in the matter of: applications for resource consents and archaeological authorities and notices of requirement by the New Zealand Transport Agency Waka Kotahi to develop a rapid transit link and associated infrastructure and connections between Brigham Creek and Auckland City centre, alongside State Highway 16, known as 'North West Rapid Transit'

Statement of Evidence of Gregory Maitland Sheppard for New Zealand Transport Agency Waka Kotahi

**STATEMENT OF EVIDENCE OF GREGORY MAITLAND SHEPPARD FOR
NEW ZEALAND TRANSPORT AGENCY WAKA KOTAHI**

Figure 2 – Modelled groundwater levels at Point Chevalier station for Scenario 1 and 2

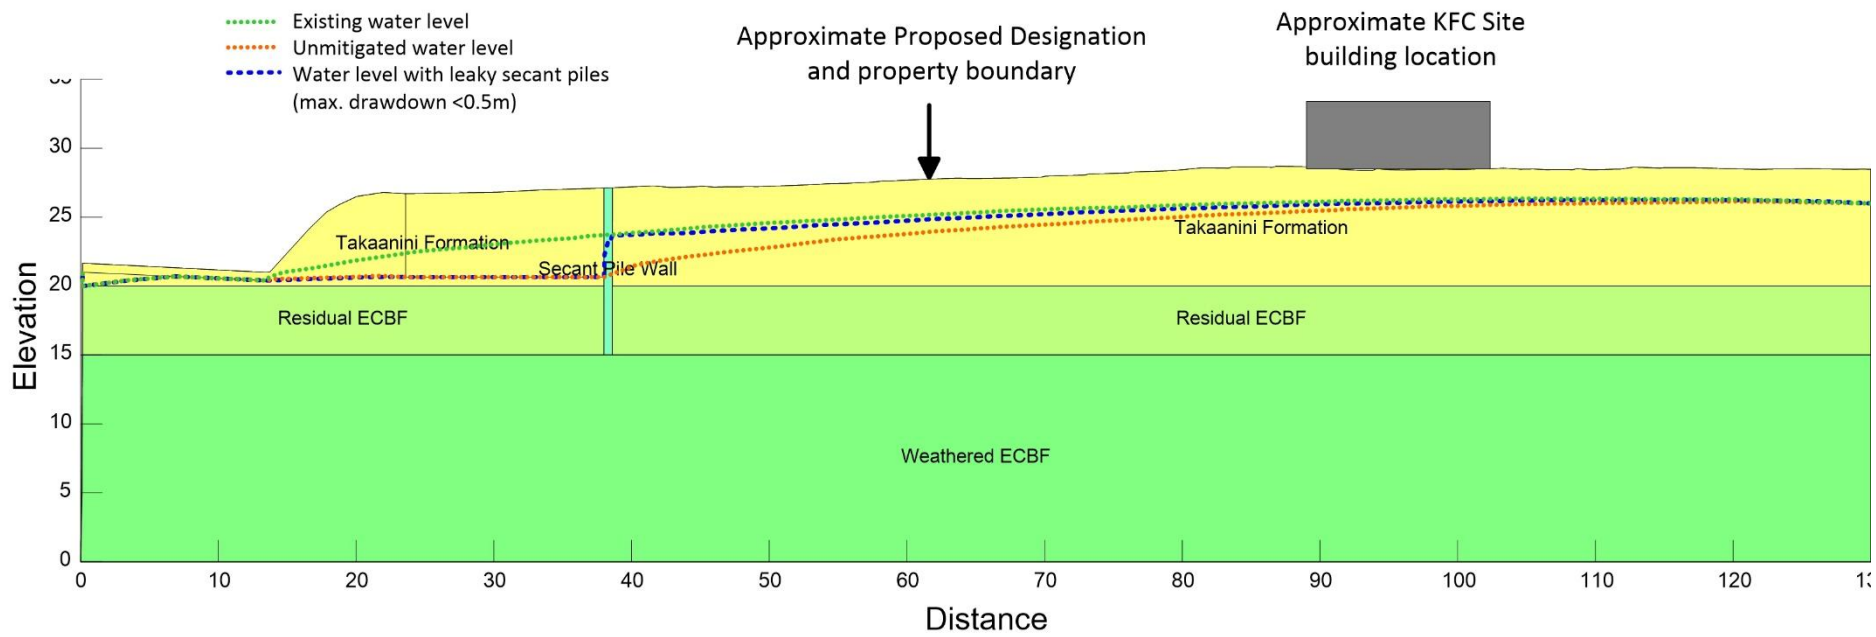
- 12 The Restaurant Brands Limited comment says the Application does not assess potential groundwater drawdown or settlement effects on 1170-1172 Great North Road, Point Chevalier (*KFC Site*). It requests a site-specific assessment of those potential effects.⁴
- 13 I have reviewed Project geotechnical and groundwater data including the groundwater model developed for Point Chevalier station and considered the groundwater conditions along the Proposed Designation at and adjacent to the KFC Site.
- 14 As shown in Figure 1 below, the KFC Site boundary is located approximately 23 m from the retaining wall for the Point Chevalier station based on the Indicative Design. The main building on the KFC Site is located approximately 50 m from that retaining wall.

- 15 The Groundwater Assessment assessed groundwater drawdown and consolidation settlement for Point Chevalier station. I consider the ground conditions and modelled groundwater levels at the Point Chevalier station location are also representative for the KFC Site.
- 16 I have undertaken an assessment of groundwater drawdown and consolidation settlement for the Point Chevalier station, which I also consider to be representative of the KFC Site, for two scenarios:
- 16.1 *Scenario 1:* Excavations with unrestricted groundwater seepage; and
- 16.2 *Scenario 2:* Excavations retained by 'leaky' secant piling or similar ground support.
- 17 The results are illustrated in Figure 2 below, which shows the location of the KFC Site and building in relation to the Proposed Designation.

- 18 The assessment predicts:
- 18.1 *Scenario 1*: Approximately 1.2 m and 0.6 m groundwater drawdown at the KFC Site boundary and building respectively. When considering an allowance of 0.5 m for historical seasonal low groundwater level, as was adopted in the Groundwater Assessment, the resulting drawdown below the seasonal groundwater low is approximately 0.7 m and 0.1 m respectively. I consider this groundwater drawdown would equate to approximately 4 mm of settlement at the KFC Site boundary, reducing to less than 1 mm at the KFC building; and

- 18.2 *Scenario 2*: Approximately 0.3 m and 0.2 m groundwater drawdown at the KFC Site boundary and building respectively, which is less than the allowance of 0.5 m for historical seasonal low groundwater levels, as such, I consider no material settlement would be expected at the KFC Site boundary or building.

- 19 Even in Scenario 1, I consider the predicted groundwater drawdown and resulting settlement is within the range that might be expected to occur naturally in reactive soils and therefore I consider it poses negligible risk when compared to standard building damage criteria.⁵

- 20 In Scenario 2, the predicted groundwater drawdown is well within expected seasonal low groundwater levels. As a result, I consider settlement and potential risk of building damage would be negligible.
